FOI Ref
10175

(CCC) Planning application 21/03609/FUL.

Request for Pre-Application Planning Advice - Developers (PREAPP)

Proposal: **BTR, apart-hotel and mixed use scheme**

MANAGING DEEP BUILDING PLAN

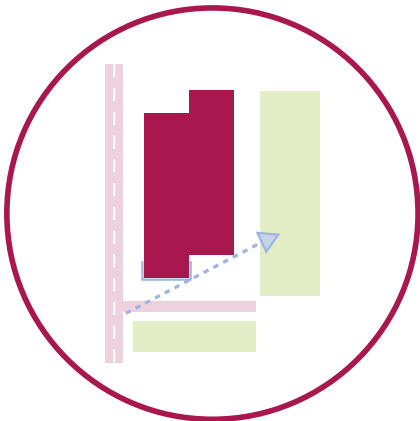
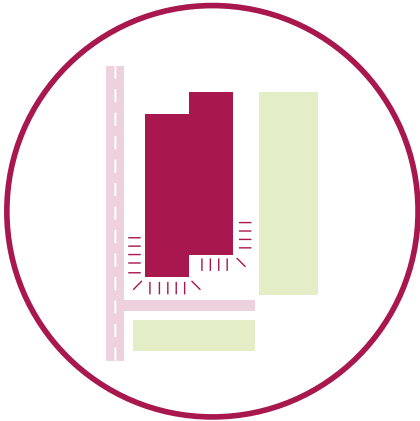
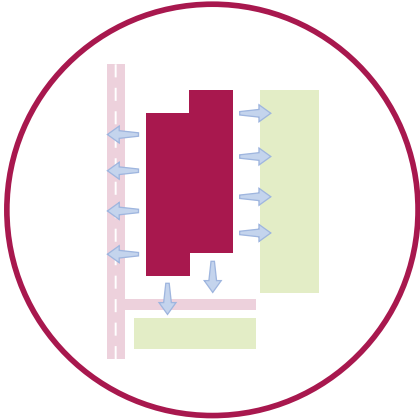
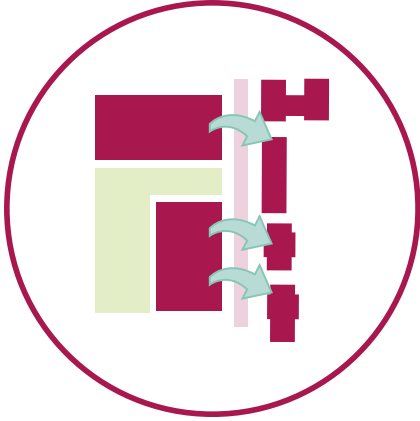
We have significant concerns about the double-banked corridors of single aspect dwellings shown on page 32 of the presentation, many of which would be west-facing and some fronting onto Lawrence Weaver Road. This will be problematic for solar gain, over-heating, daylighting and air circulation. This is poor both from a sustainability perspective and in terms of the quality of the internal accommodation. You need to look at dual-aspect dwellings and consider

duplexes which would benefit from an element of passive stack ventilation. We recommend that you carry out some detailed overheating analysis of a sample of dwellings using the CIBSE methodology using both current and future climate scenarios.

The façade design must respond to the need to design out the risk of overheating and reduce the amount of solar gain in the summer and shoulder months. You need to think about external shading (vertical shading will work best on the west facing elevations, horizontal on south facing – some of this can be dealt with via balconies but this comes with its own issues) and consider the implications of any acoustic constraints on window openings (so there may be a need for acoustically attenuated vents at ground floor and for any other units where window opening may be restricted). It is important that this is considered early on so that architectural responses to environmental issues can be designed into the scheme and not as an afterthought.

As well as the sustainability issues with double-banked single-aspect units, we also have concerns that when these are arranged in long anonymous corridors they create a poor sense of place, home and identity. You should consider smaller clusters, with primarily vertical circulation. Gallery (or decked) access could form part of an alternative approach and rethink of the typologies. Done well, and limited in length, galleries/decks can become an additional outdoor space and an extension of the living space. Duplex homes (apartments over two floors) should also be considered for upper floors, this can help to create a more articulated roofscape and produce upper floors that are more recessive and read more like rooms in the roof. Duplex homes also help to mitigate lift overruns as shared circulation is not required to the upper most floors.

RESPECTING THE BUILDING OF LOCAL INTEREST

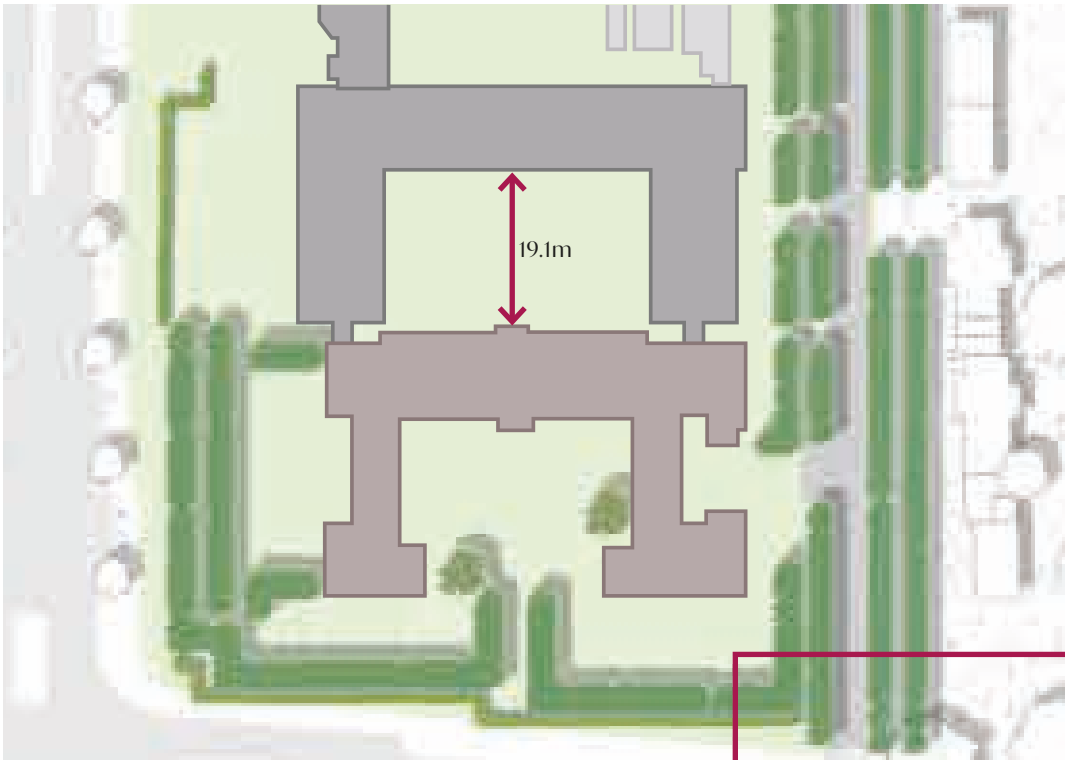
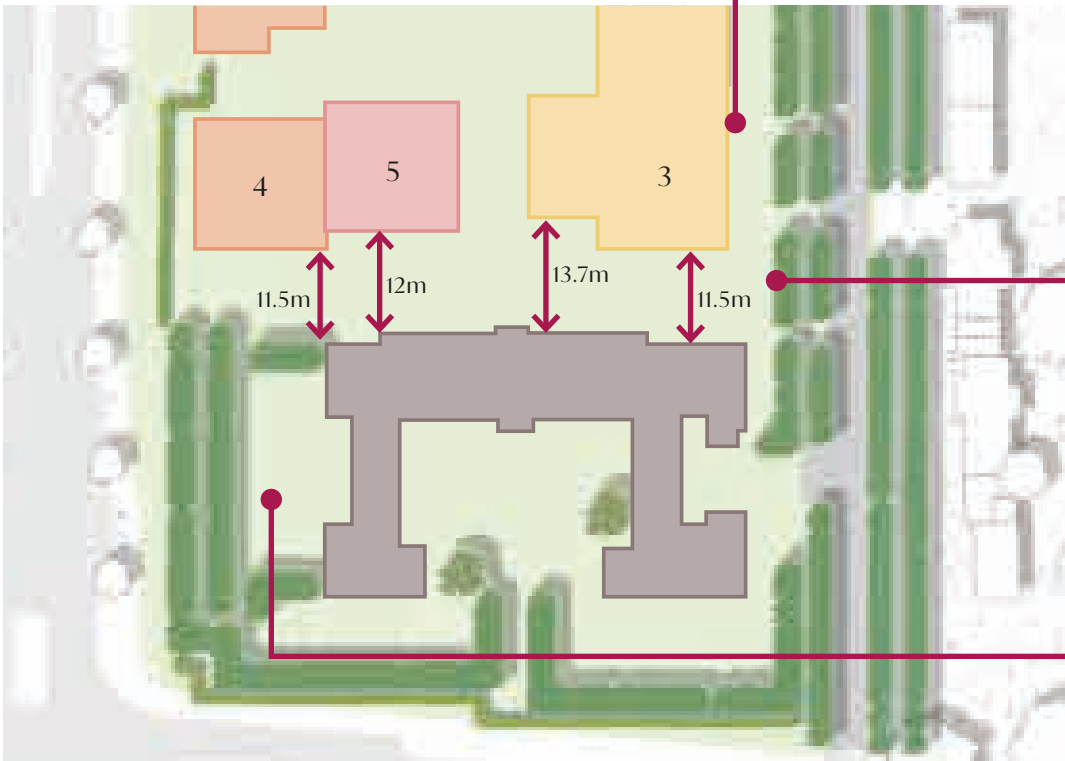
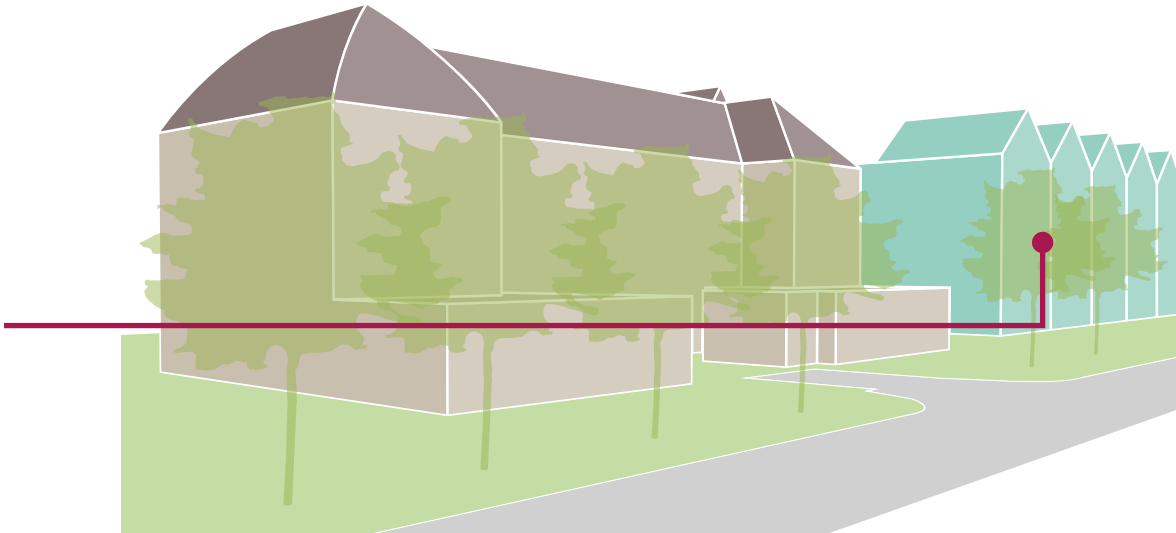
At the southern end, the block near (or linked to) the NIAB building needs to respond to the BLI in terms of the scale, positioning and character. This will require a more careful analysis and understanding of the character of the NIAB building, its setting, and how the scheme then interfaces with it. Currently, the proposal shows the southern block very close the existing NIAB building and in scale/massing terms will loom over and dominate the BLI. The southern block

does not appear to relate functionally to the existing NIAB building, despite that both will be in the same use as the apart-hotel. The space to the north of the NIAB building is also a non-space.

The response should enhance the setting of the BLI and not dominate it. It is interesting how the existing 1960s building relates (not aesthetically) to the existing NIAB building by stepping down in scale. The maximum height of the southern block should not exceed the overall ridge height of the NIAB building. Perceived visual bulk also relates to eaves and parapet heights and these should be referenced with narrow span pitched roofs. As a starting concept for a more sensitive response, the southern block could work better as a 'U'-shape block, with the building line of the NIAB building defining the eastern and western envelope. The formal landscape would continue around Lawrence Weaver Road. It maybe that the northernmost part of this block could push out closer to Lawrence Weaver Road to transition with the rest of the scheme.

Whilst the demolition of the poor quality 1960s extensions is likely to be acceptable, precisely how this is done to the BLI needs careful assessment. A site visit will be necessary to understand how the 'modern' construction links to the original [1920s ?] building and how the detachment can take place without loss. Such a site visit would also enable a judgement to be made as to whether physical links to an 'Apart Hotel' block behind are feasible or desirable. Even if physical links were to be found acceptable, the type, number and nature of the form & construction would be vital. Done well, this could be an opportunity to celebrate the NIAB building as a special part of the scheme and townscape, and not as a separate and forgotten element.

BOUNDARY CONDITIONS

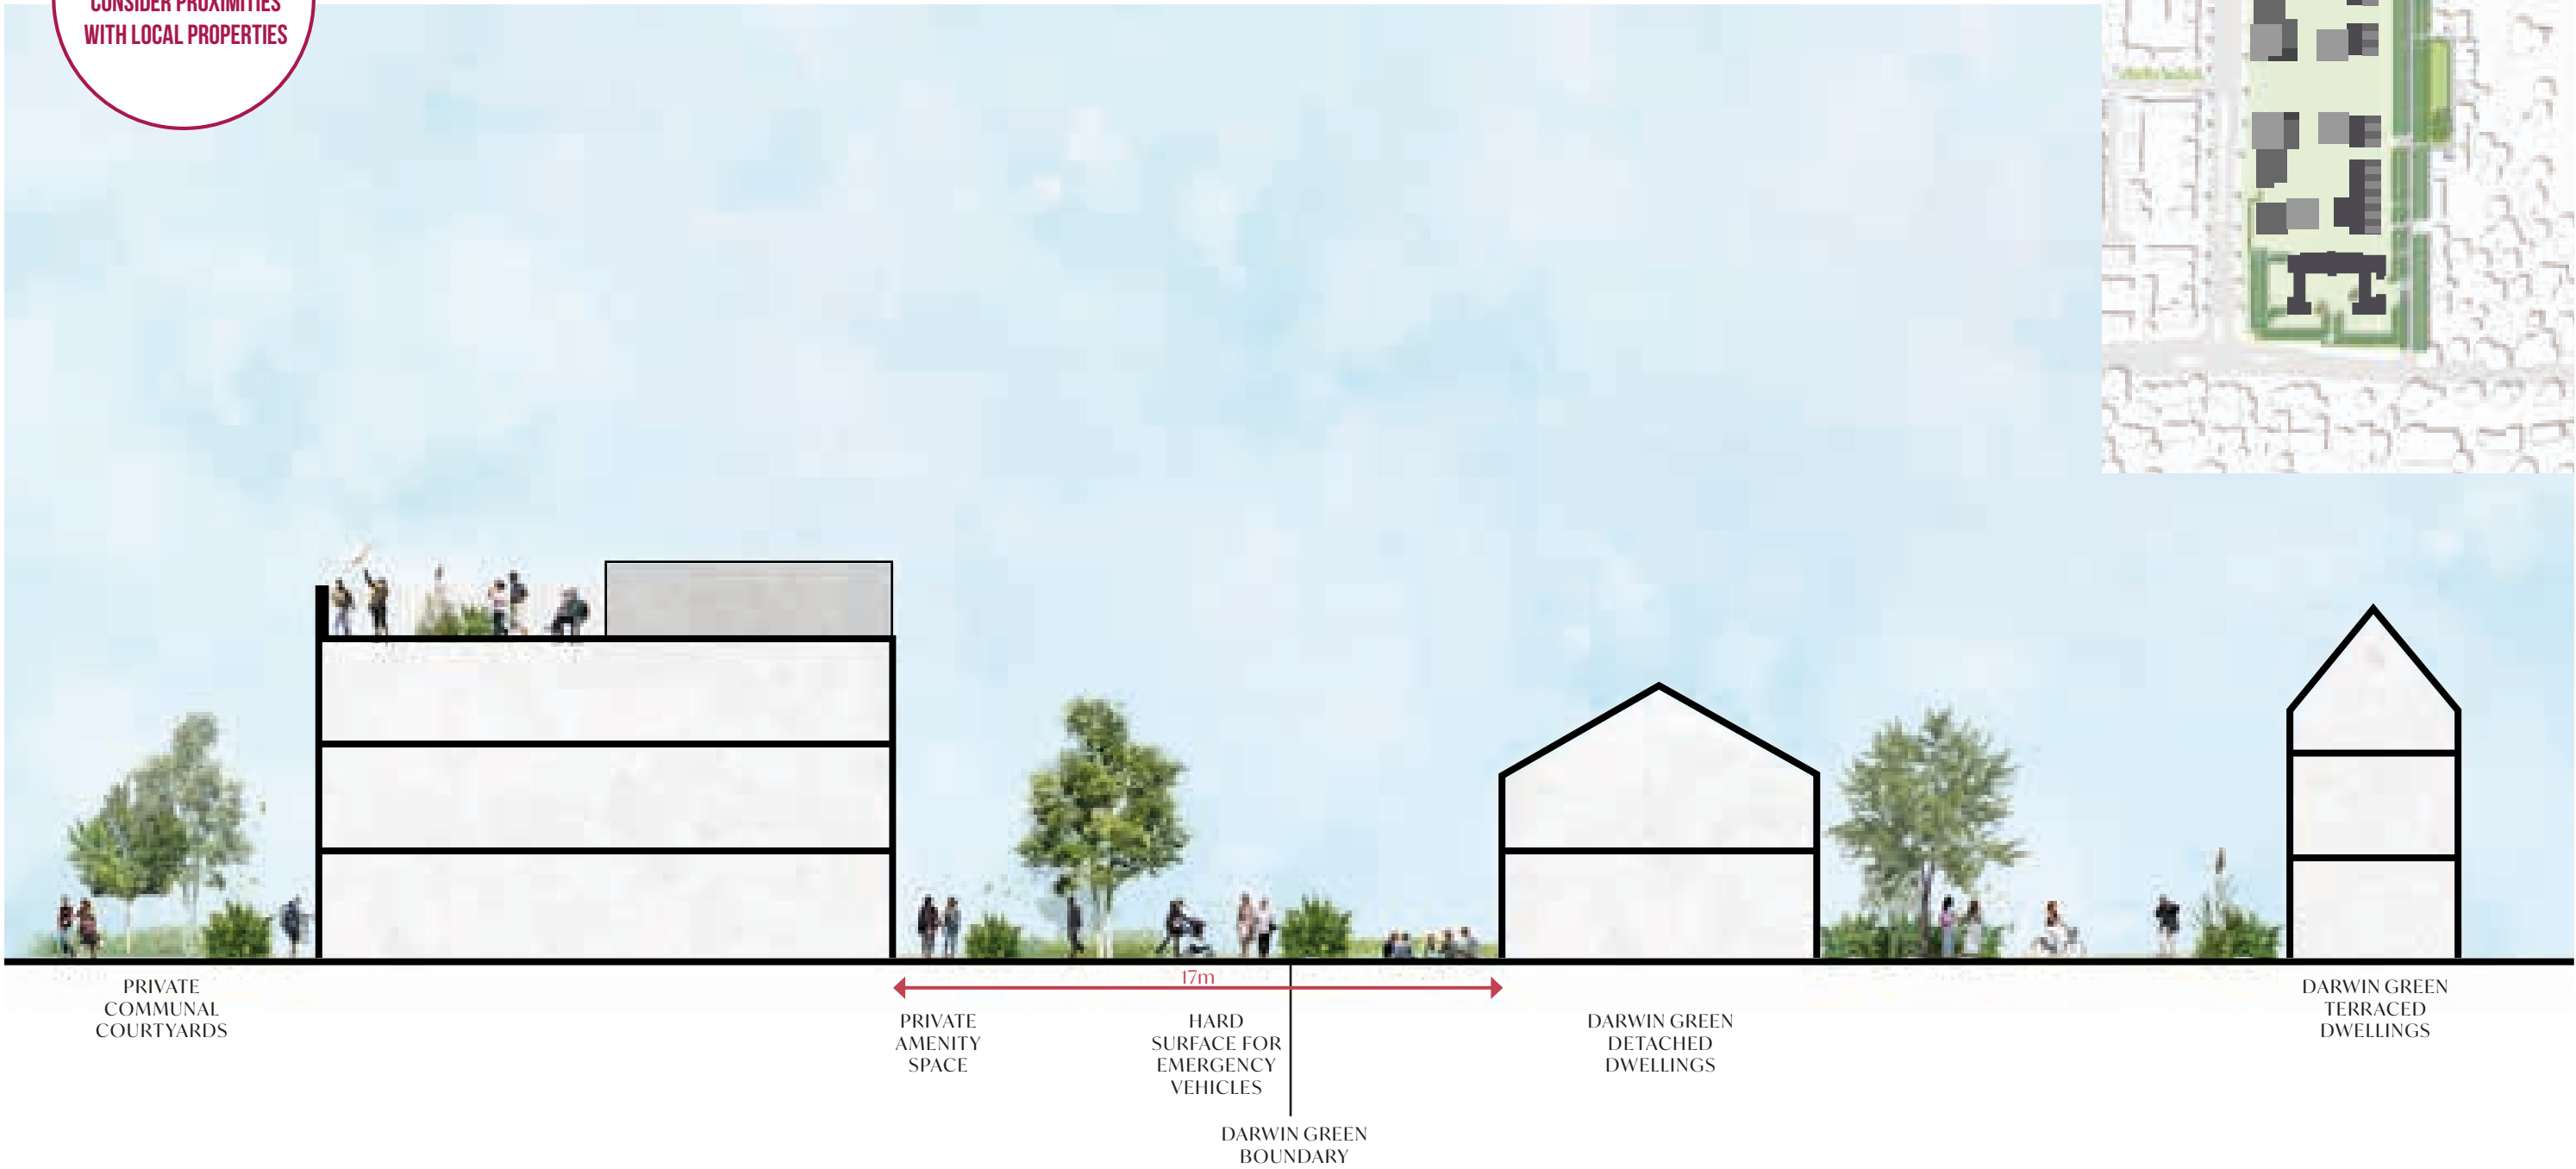
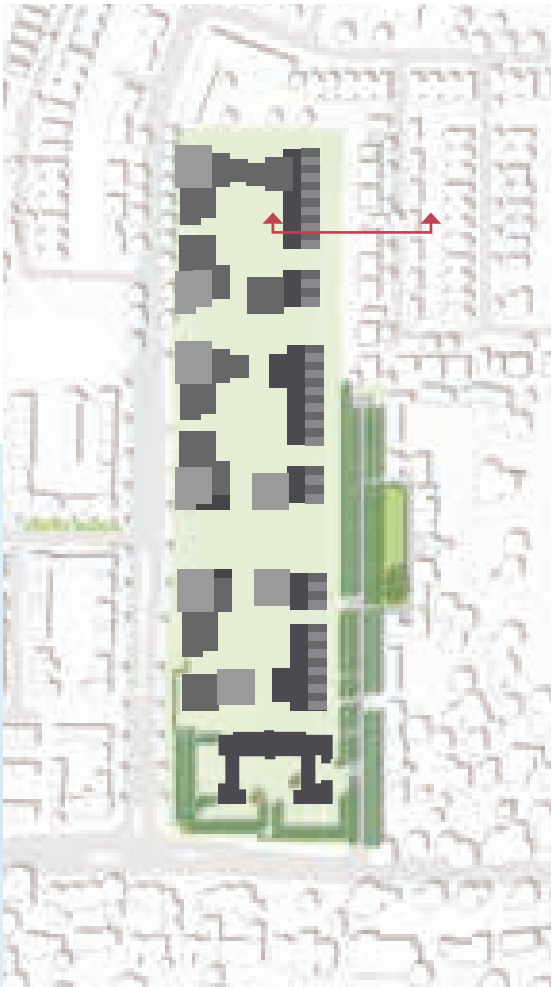
At the northern end, the large block creates amenity issues with the neighbouring residential properties. The Darwin Green parcel BDW1 homes that back onto the top eastern edge are very domestic in scale (2 storey) and have small rear gardens. The proximity and height of the northern block is likely to lead to loss of privacy, overshadowing and potential overbearing impacts. There is also a strange and confused front to back relationship along the eastern edge with 'fronts' of the perimeter blocks – including main entrances to the buildings - facing onto the back of the BDW1 properties. The basic shape of the block needs a rethink to address this. As a starting concept, a 'C'-shape block open on the eastern edge could help to resolve these issues, however this would create a front condition facing onto the backs of the BDW1 forms along northern edge of the site. Evolving this further, it appears to us that more fine-grained options should be explored here, where a series of shallower and lower building forms with rear amenity space, could back onto both boundaries.

Whilst it is considered that the frontage along Lawrence Weaver Road could take a sense of increased scale, the cross-sections showing the proposals adjacent to existing buildings are – in every case – excessively tall. The scale must relate to the immediate context. The northern block should have a character and scale related to its immediate environs and location adjacent to Darwin Green. The central block must relate strongly to the domestic scale and fine-grained forms of Howes Place and Darwin Green. To complete the street of Howes Place in a convincing way it must be informed by a more refined understanding of the character and quality of Howes Place itself. The southern block should not exceed the height of the NIAB building.
